Al Muslim Apparels Ltd. (New Building)

6 March 2024

Observation-1: Inconsistency in the design report (Main Building-2).

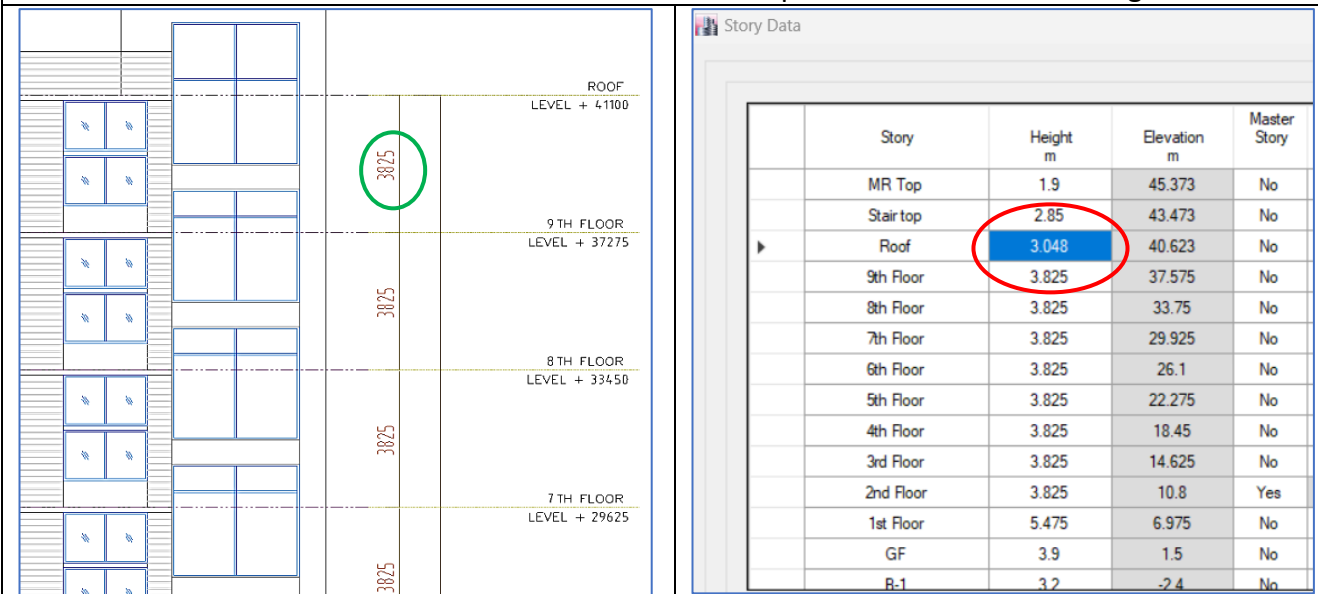
The green marked RC walls are not properly incorporated in the analysis model. In the analysis model discontinuous RC wall observed which does not match the provided structural drawing.

Building elevation height is mismatching with the analysis model and provided drawing. The 9th floor height considered 3.048m in analysis model and 3.825m considered in the provided drawing.

Calculation of Building Height Exp. Value, K

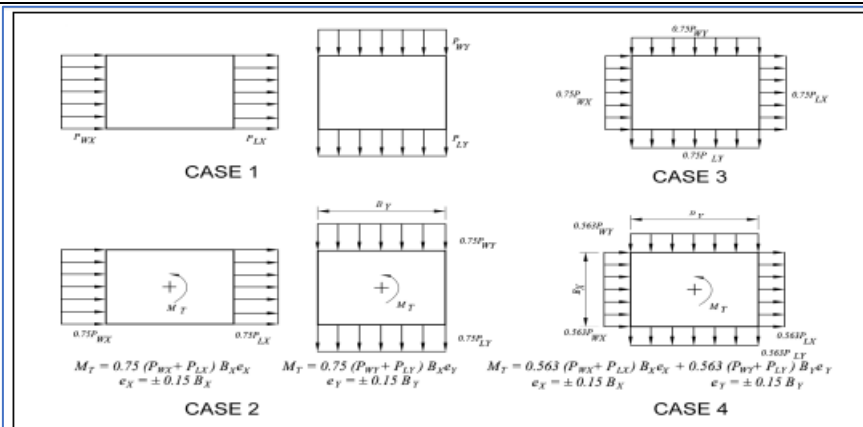
In the analysis model seismic parameters assignment mismatching with the design report calculated base shear coefficient C and building height exp. K.
